SIR JOHN SOANE'S MUSEUM  
MAINTENANCE CONTRACT

ROOF ACCESS ALTERATIONS DRWG 506MA/SK130A  
SECTION E SCALE 1:100 @ A3  
AS PROPOSED DATE JUL. 2022

SECTION E  
AS PROPOSED

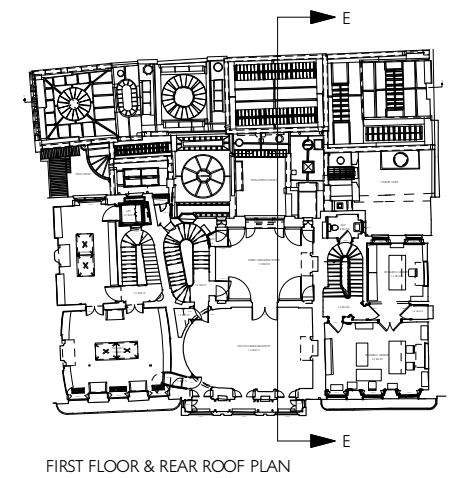
- ① New galvanised steel access ladder to replace the existing ladder in the similar position. Ladder to be detailed as detailed drawing 506MA/SK119.

DRAWING REVISIONS: -  
Rev. A: Ladder handrail design altered.
